Rezoning Transportation Analysis

Petition Number: 2021-176

Date	Description
11-19-21	First Review (TM)

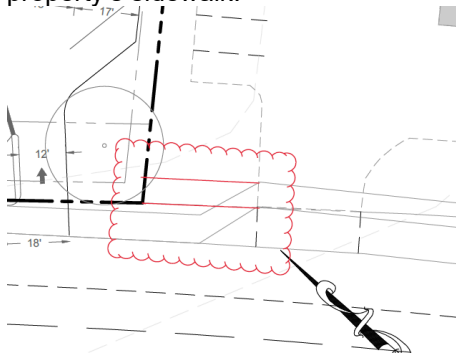
1. **Curbline:** The proposed zoning district has a setback measured from back of the existing or proposed future curbline.
 - a. **Randolph Road:** The future location of curb and gutter will be 41-feet measured from the existing centerline to the back-of-curb. Label and dimension the existing and future back-of-curb from the existing centerline.
